MECKLENBURG COUNTY HEALTH DEPARTMENT

APPLICATION FOR PERCOLATION TEST

SUBJECT: APT #6303 (Waco Realty Co.)
Lot No. 54 on Powell Street
8-31-73

SOIL INVESTIGATION REPORT

DIAGRAM OF PROPERTY

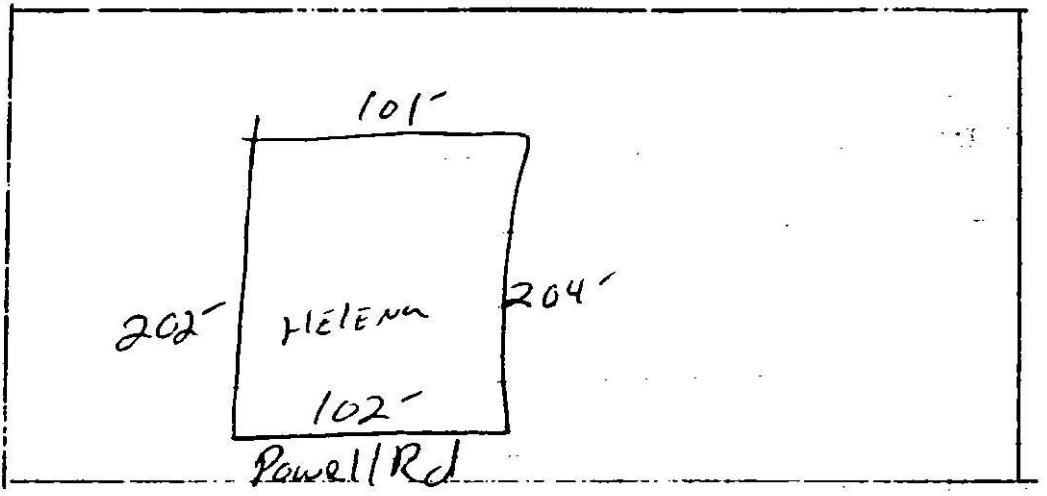
Soil Properties	Soil 1	Soil 2	Soil 3	Soil 4
1. Soil Series	Helena			
2. Soil Slope	unsuitable depression			
3. Soil Depth	suitable 48"+			
4. Soil Texture	unsuitable silt/expanding clay			
5. Soil Structure	unsuitable massive			
6. Restrictive Horizons	—			
7. Soil Drainage	unsuitable perched high water table			
8. Soil Permeability (Percolation Rate)	unsuitable very slow >200 min/in			
9. Other	—			
10. Overall Rating	unsuitable

Recommendations Based on this investigation, the lot is not recommended for approval for installation of a septic tank system.

See diagram on back
